**RE: Generations at West Mesa
5710 Avalon Rd NW
Grading and Drainage Plan
Engineer's Stamp Date: 04/11/18
Hydrology File: K11D084**

Based upon the information provided in your resubmittal received 04/17/2018, the Grading and Drainage Plan is approved for Building Permit and Grading Permit.

Cypress Civil Development has compiled the following responses to the comment letter received from City of Albuquerque Hydrology Department for the above mentioned project. The responses are listed by heading below:

**A** RETAINING WALL DETAIL
N.T.S.**C** RETAINING WALL DETAIL
N.T.S.

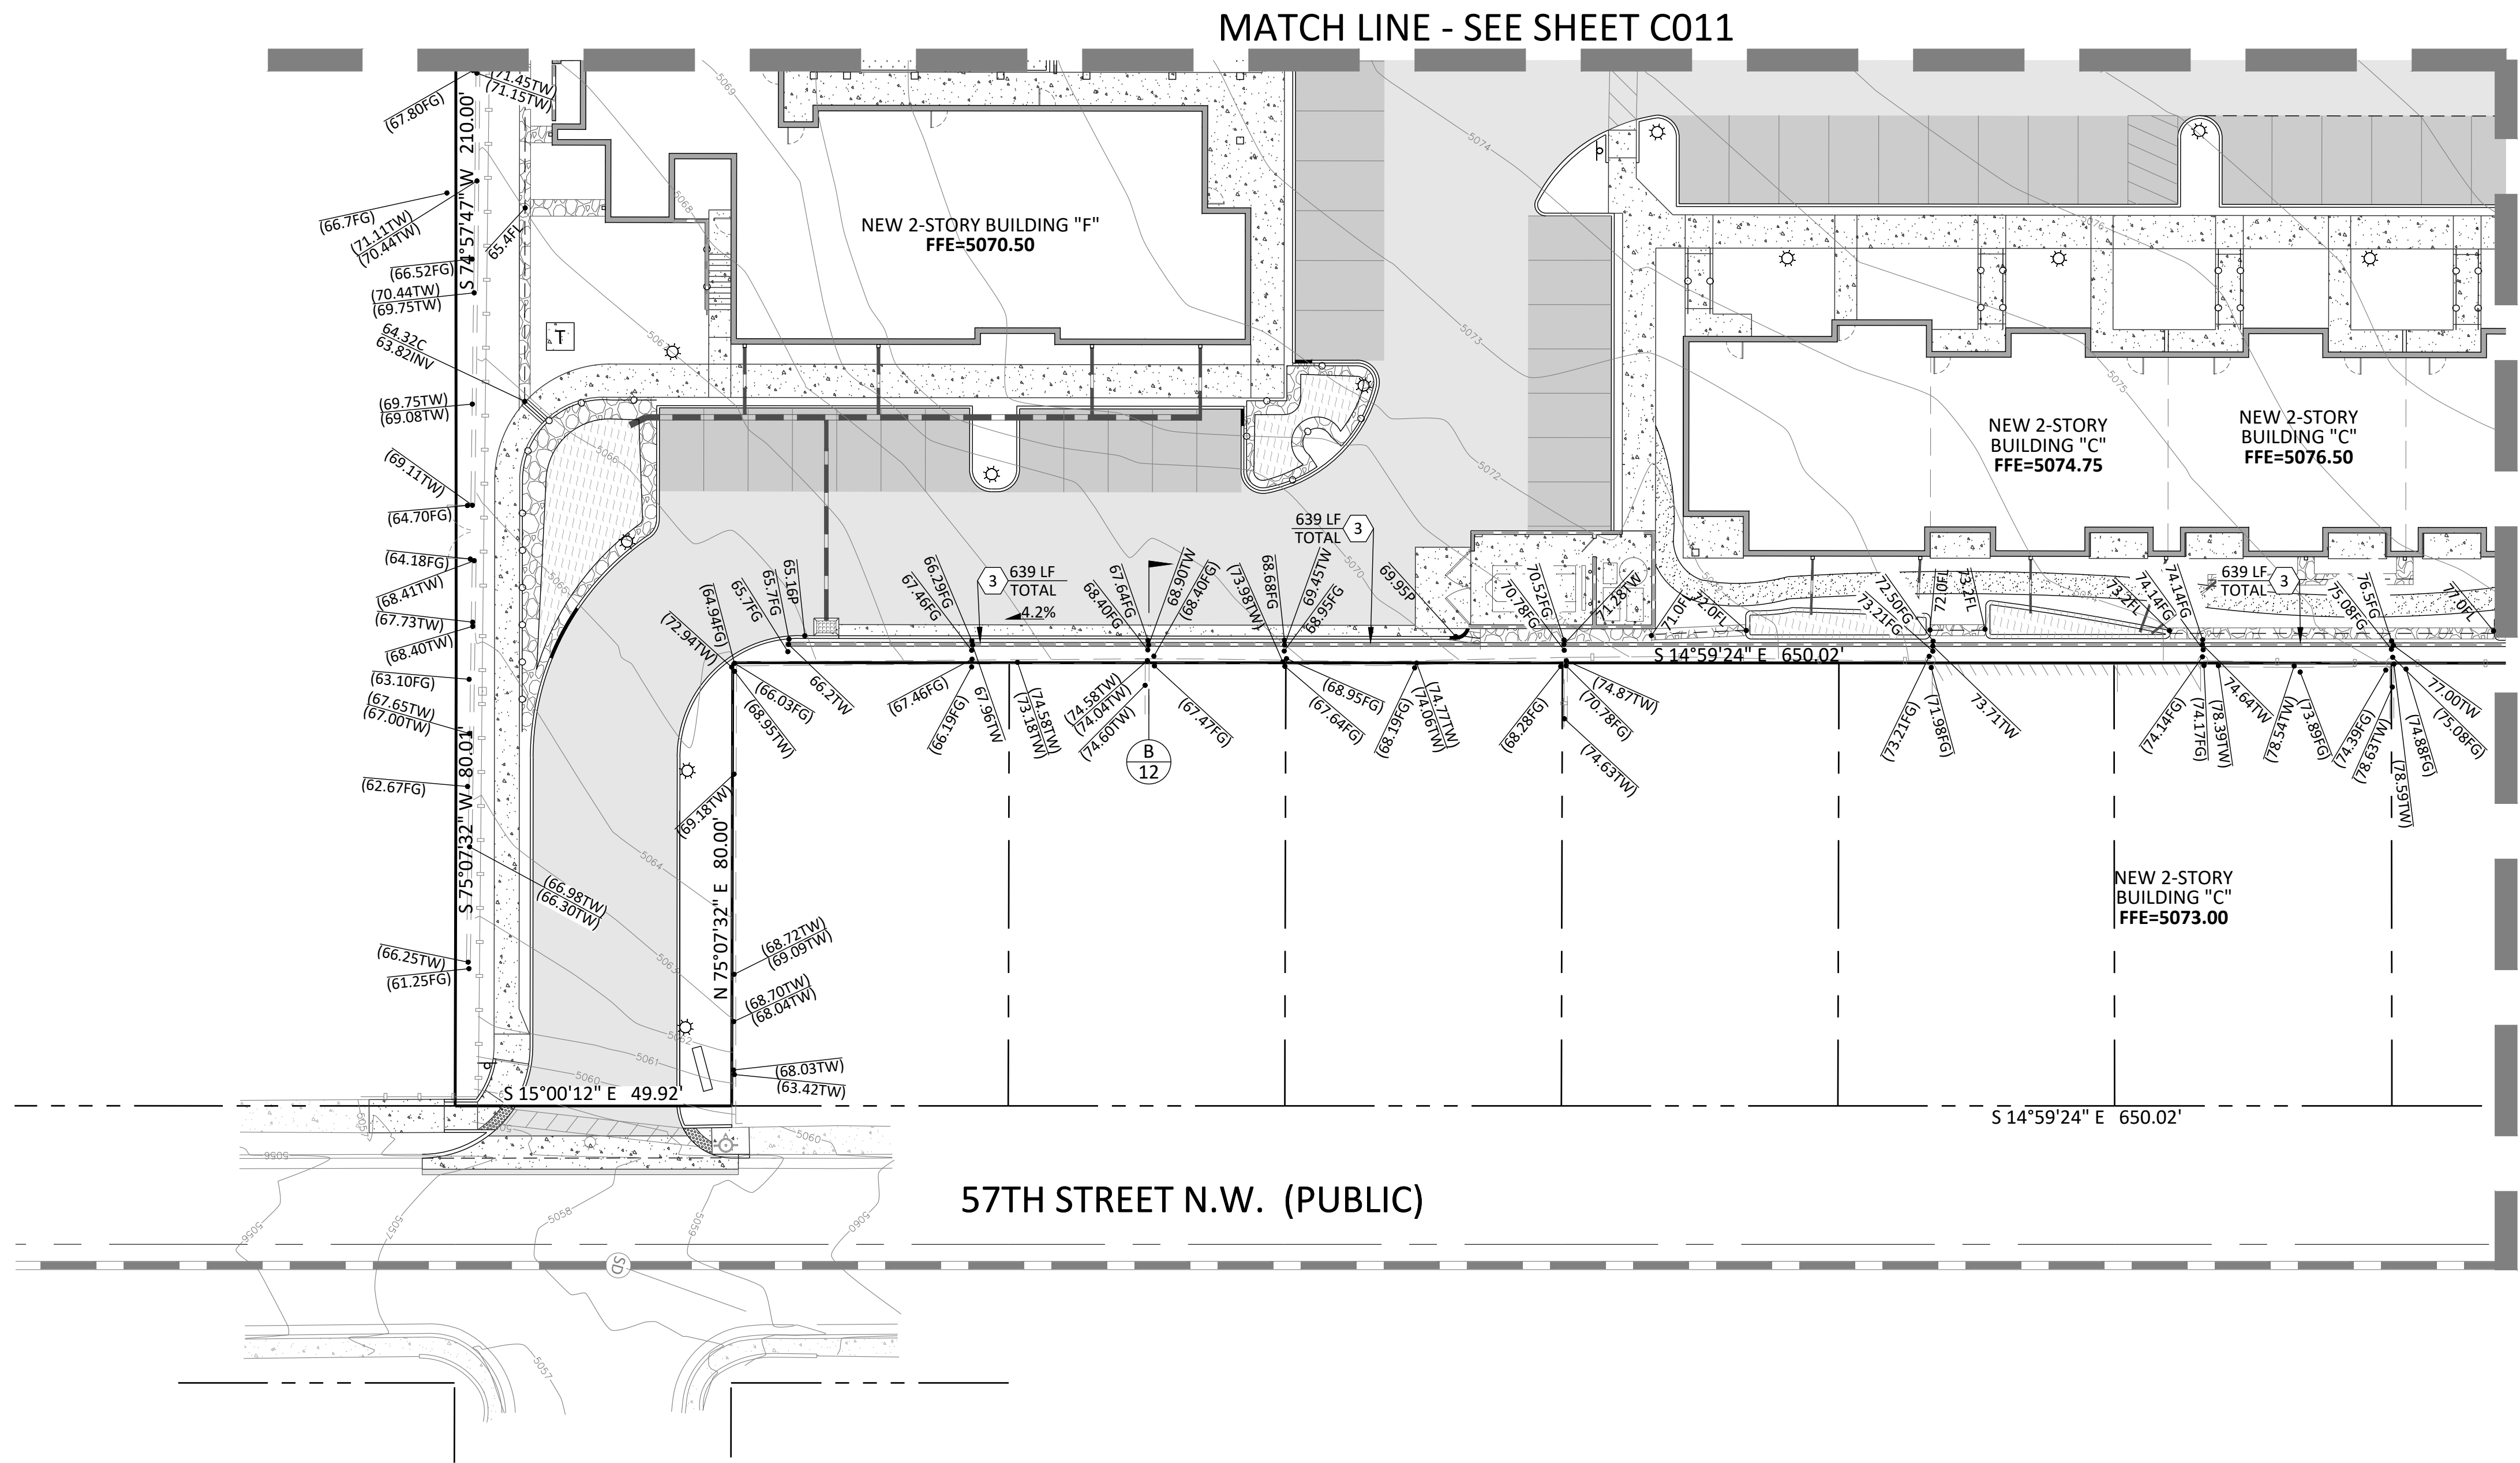
Comment 21 – Complied. The pressure of the existing walls has been accounted for in the new wall and footing designs (confirmed with the Structural Engineer). The new footing does fall within the angle of repose for the existing footings at the tallest portions of the new retaining wall. This was discussed with the structural engineer and a note has been added to the structural detail:
“WHERE ADJACENT EXISTING WALL(S) OCCUR, THE CONTRACTOR SHALL SHORE EXISTING WALL(S), FOOTING(S), AND ALL UNDERLYING SOIL AS REQUIRED TO PREVENT ANY SLOUGHING OF SOIL OR MOVEMENT OF EXISTING WALL(S) AND FOOTING(S).”

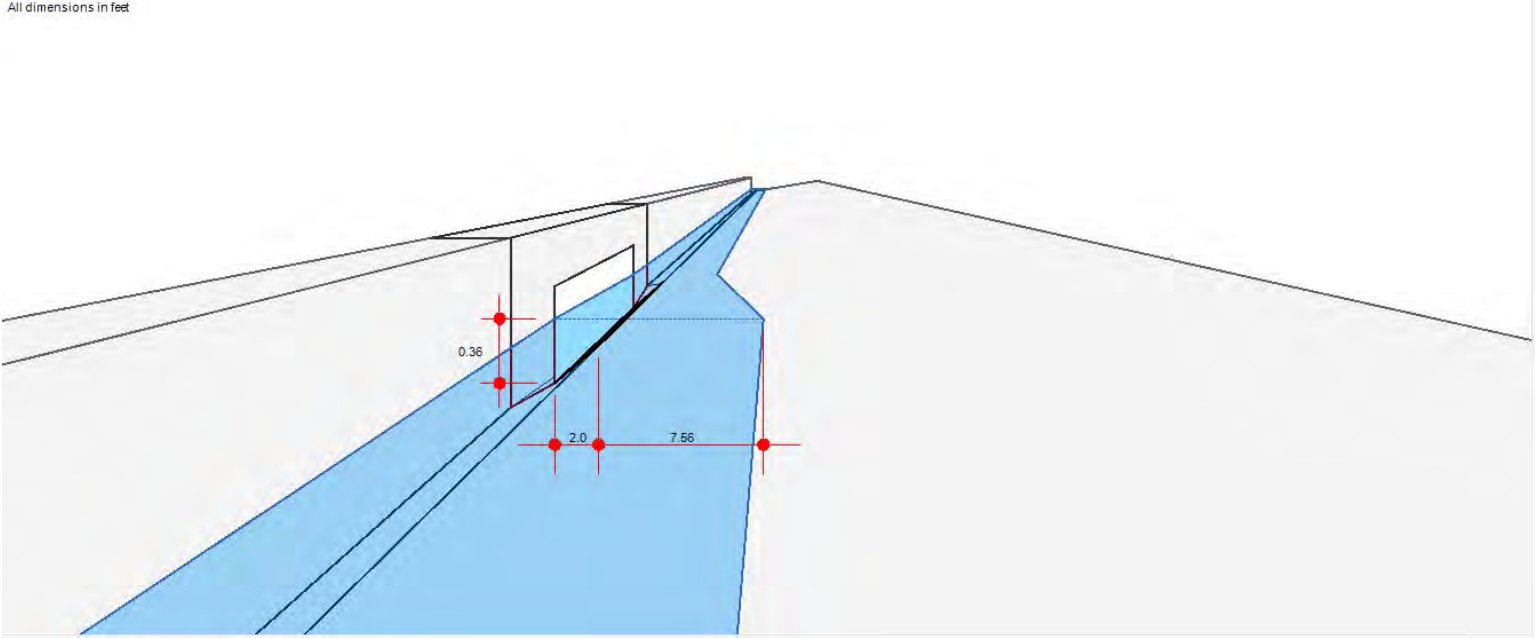
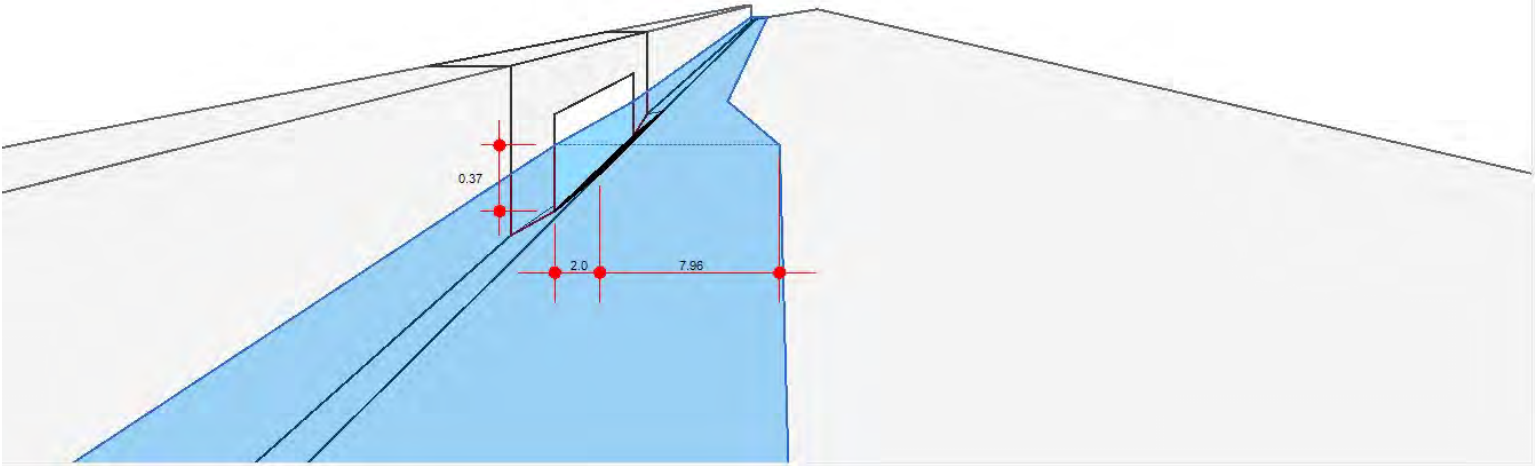
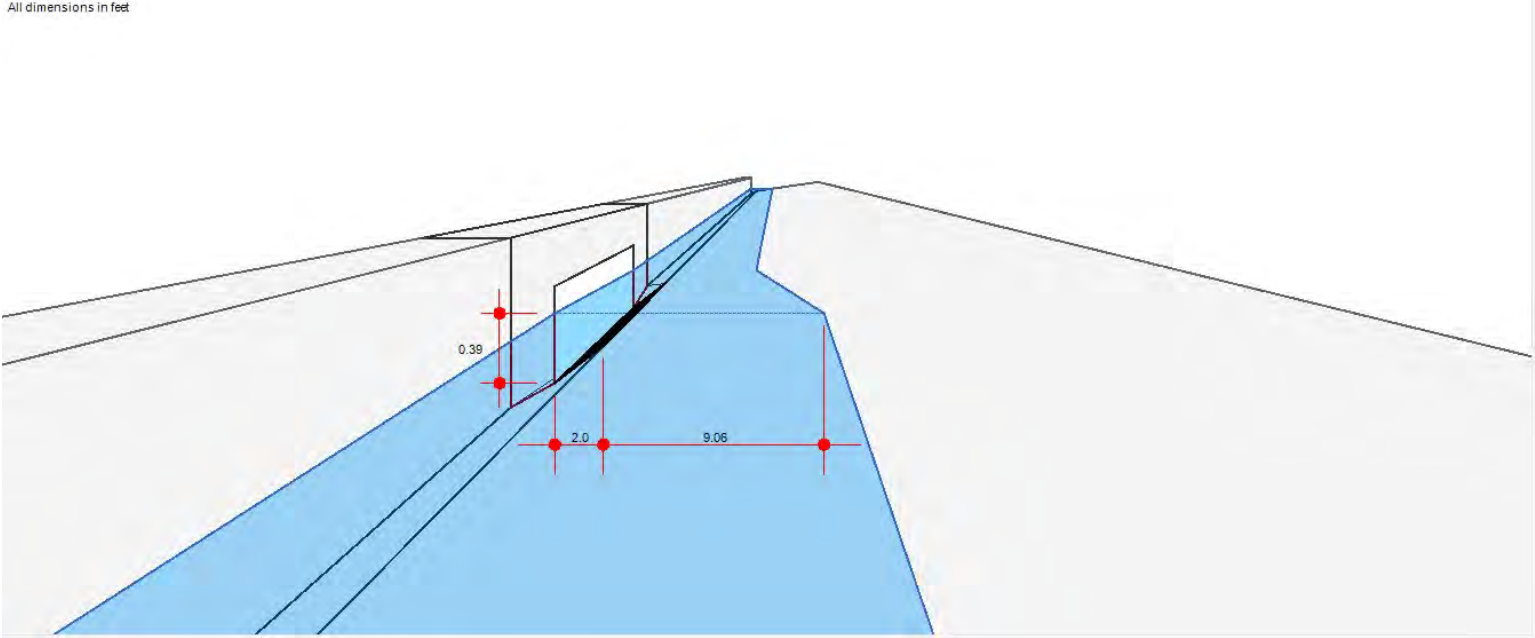
Comment 17 – Complied. The inlet calculation for the proposed single “D” catch basin is now provided.
